RECORD DRAWINGS

THESE RECORD DOCUMENTS WERE PREPARED BASED UPON HARD COPY MARKUPS PROVIDED BY AUI, INC., COA DMD & ABCWUA. HDR DID NOT VERIFY THE INFORMATION PROVIDED BY AUI, INC., AND THE PREPARATION OF THESE RECORD DOCUMENTS IS LIMITED TO INCORPORATING SUCH CHANGES INDICATED BY AUI, INC., COA DMD & ABCWUA. NEITHER HDR NOR OUR SUBCONSULTANTS MAKE ANY REPRESENTATIONS, WARRANTIES OR GUARANTEES, EXPRESSED OR IMPLIED, AS TO THE COMPLETENESS OR ACCURACY OF THE INFORMATION CONTAINED ON THESE RECORD DOCUMENTS. THE USER OF THE INFORMATION PROVIDED ON THESE RECORD DOCUMENTS ASSUMES ALL RISK. ALWAYS FIELD VERIFY THE ACTUAL LOCATIONS OF ALL INFORMATION PRIOR TO BEGINNING ANY CONSTRUCTION ACTIVITY.

DEPARTMENT OF MUNICIPAL DEVELOPMENT CONSTRUCTION PLANS FOR UNSER BLVD. IMPROVEMENTS - SAGE TO CENTRAL COA PROJECT NO. 7699.91

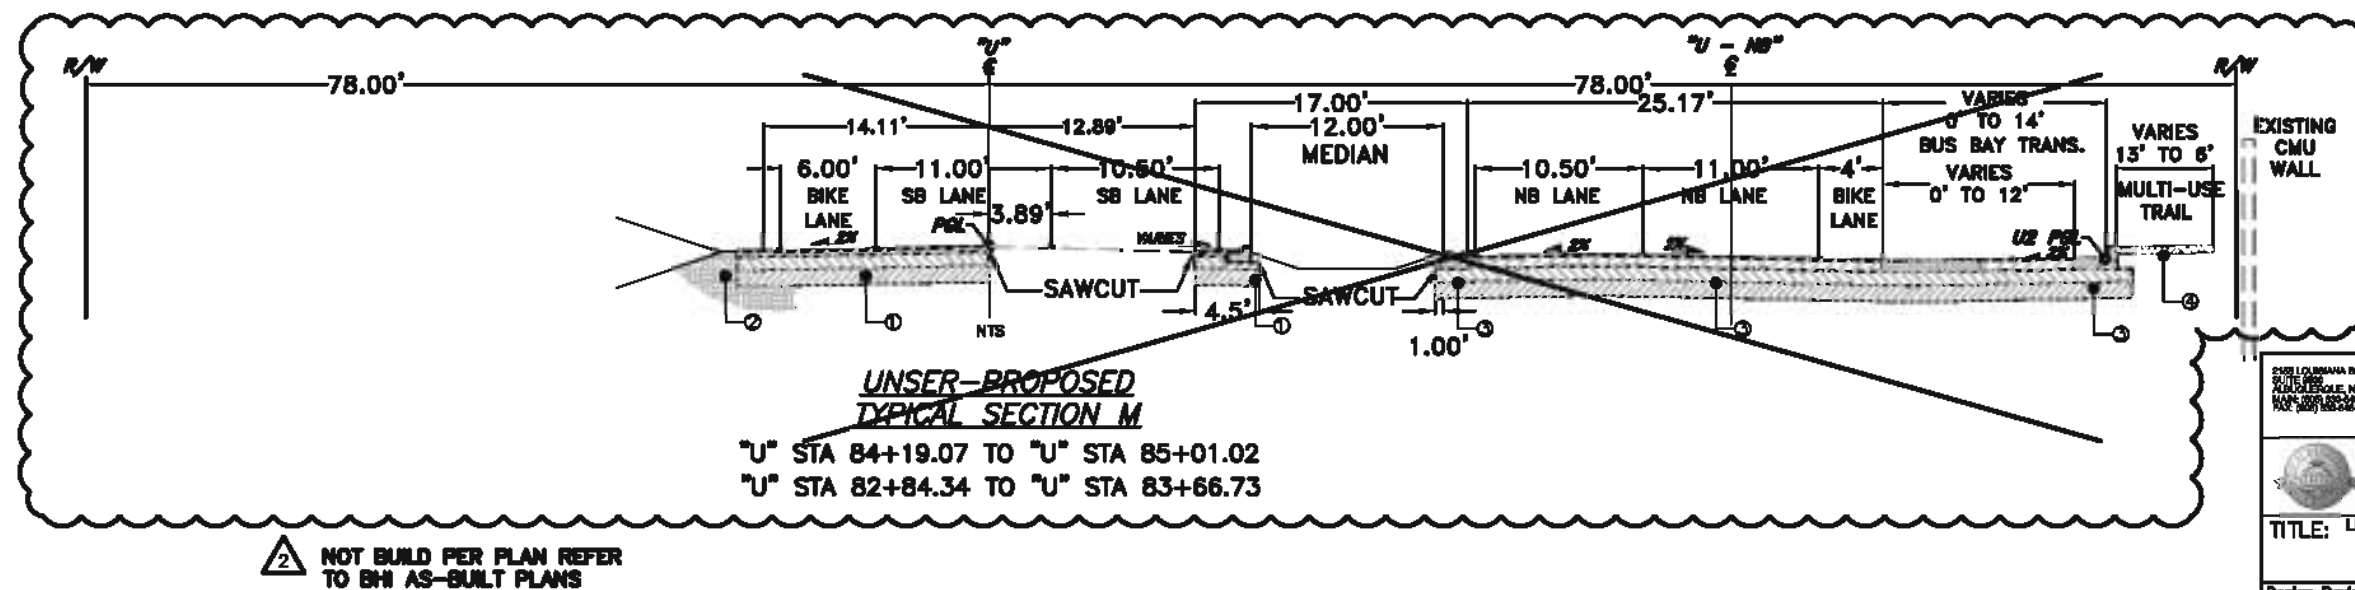
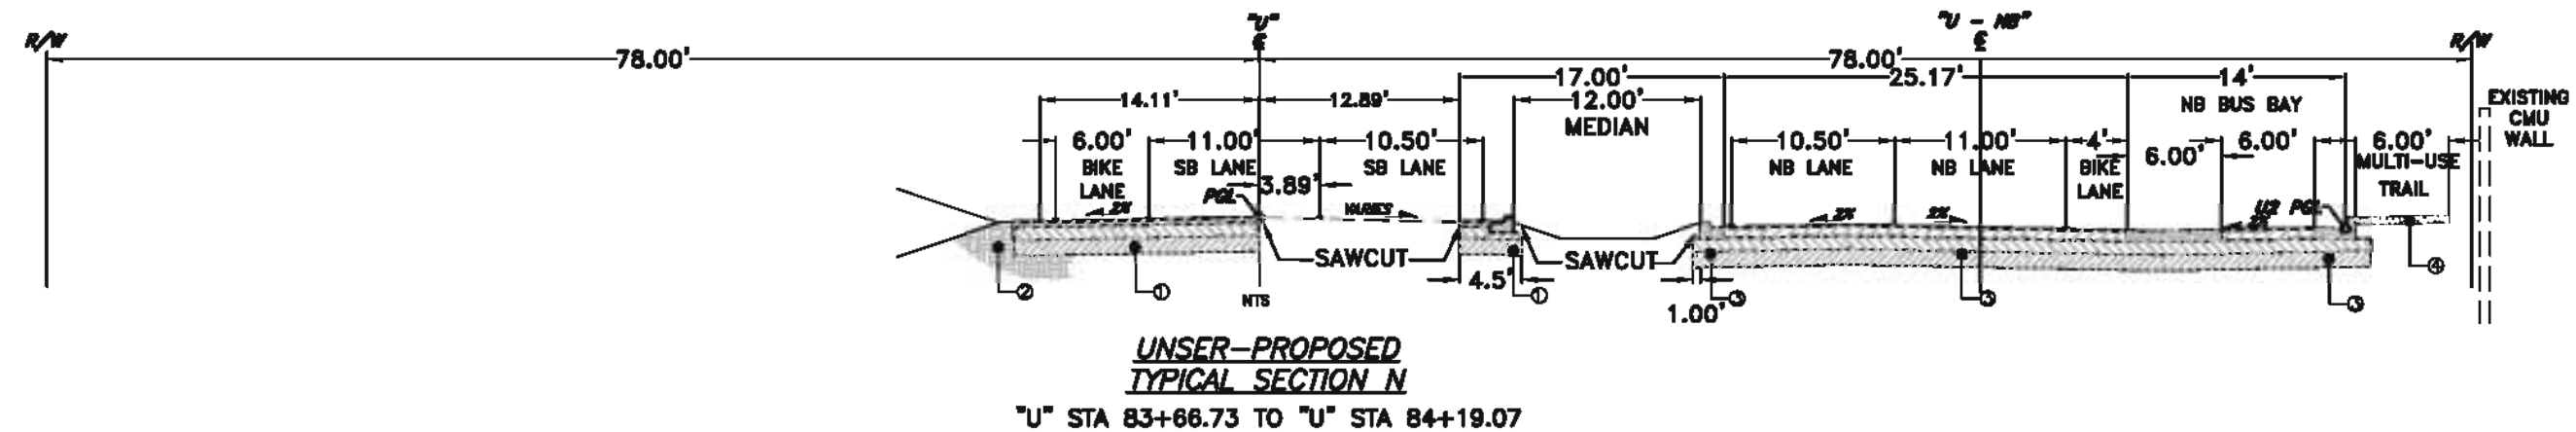
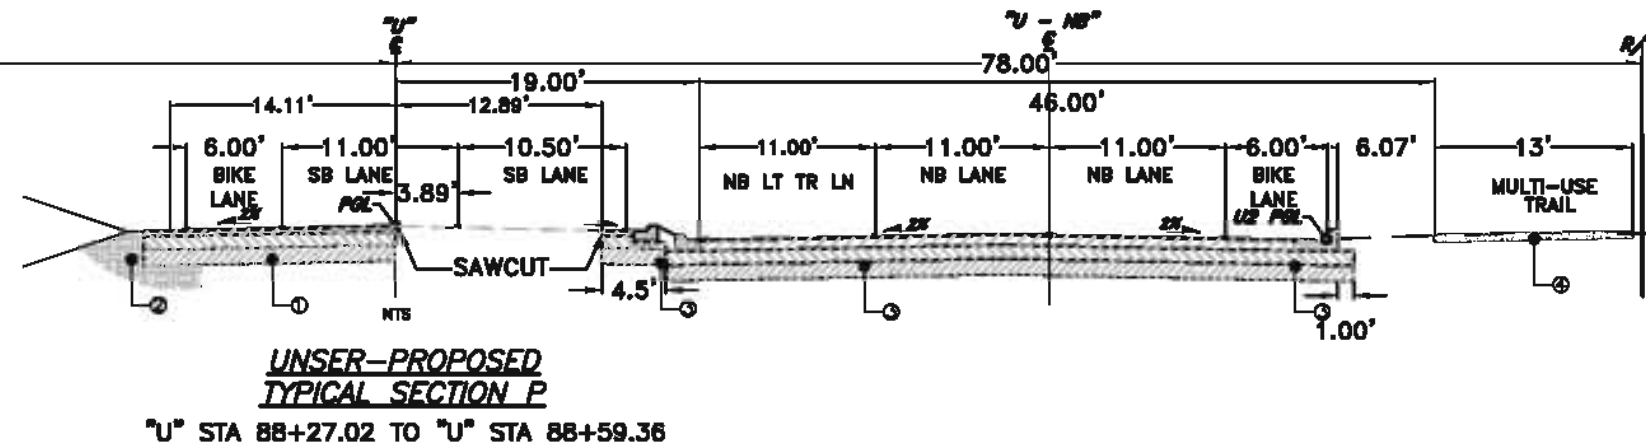
2 NOT BUILD PER PLAN REFER TO BHI AS-BUILT PLANS

City Project No. 7699.91 **Zone Map No. K10, L10** **Sheet 37 of 82**

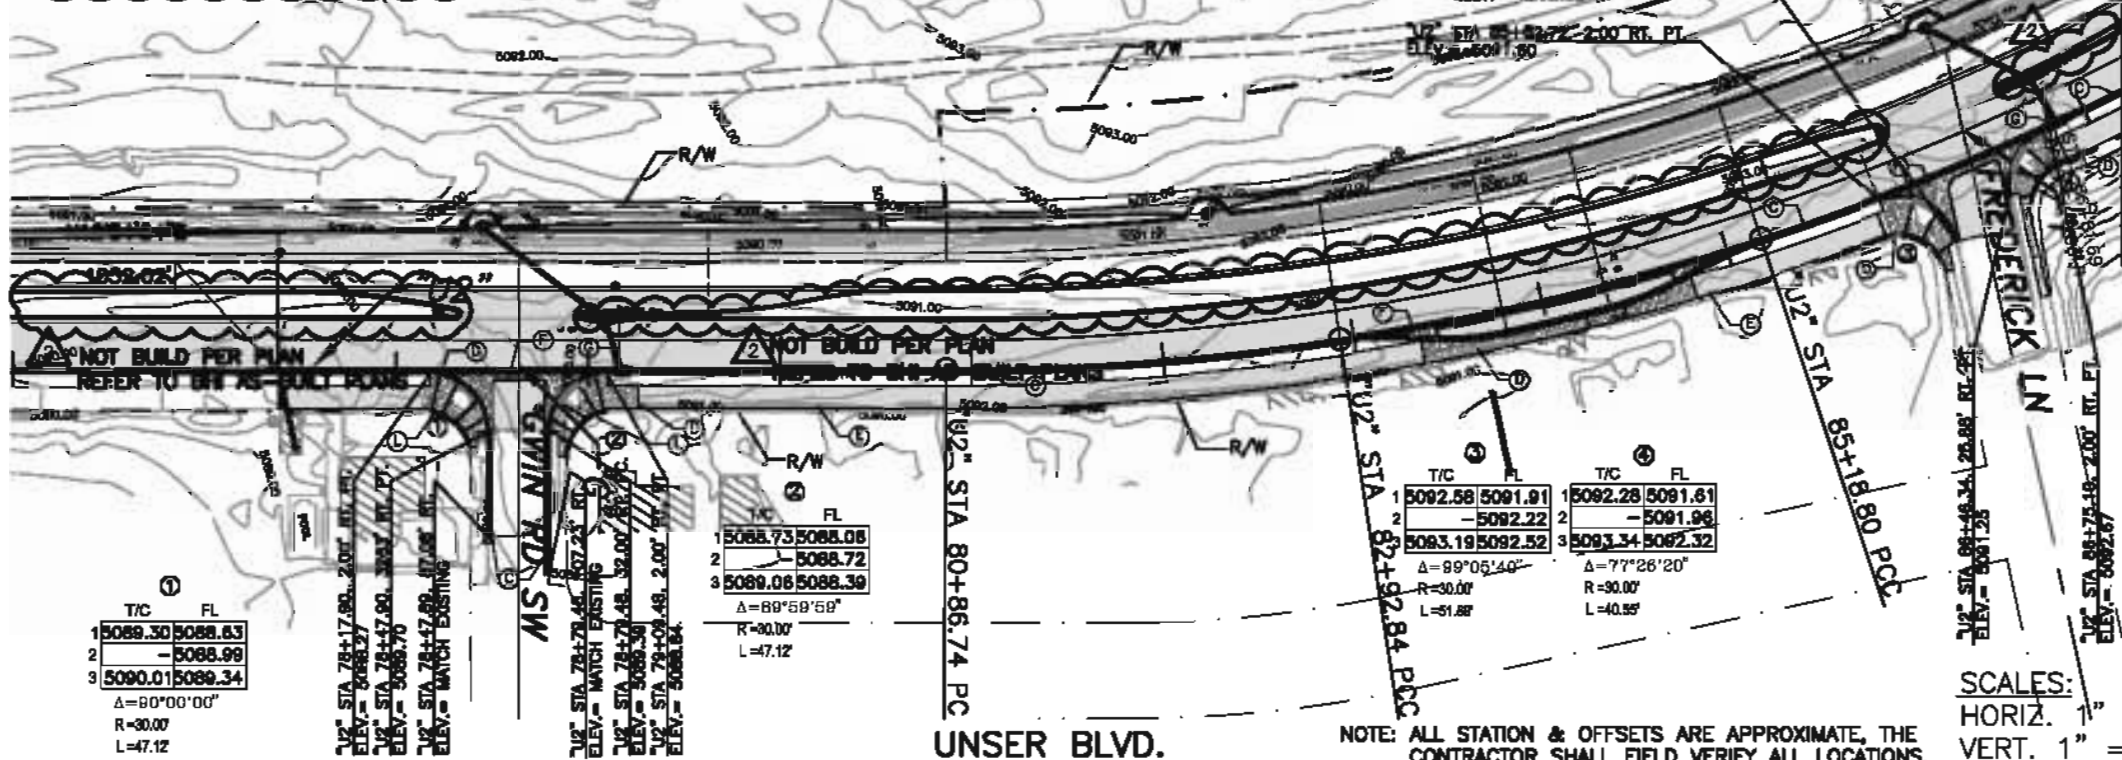
2 NOT BUILD PER PLAN
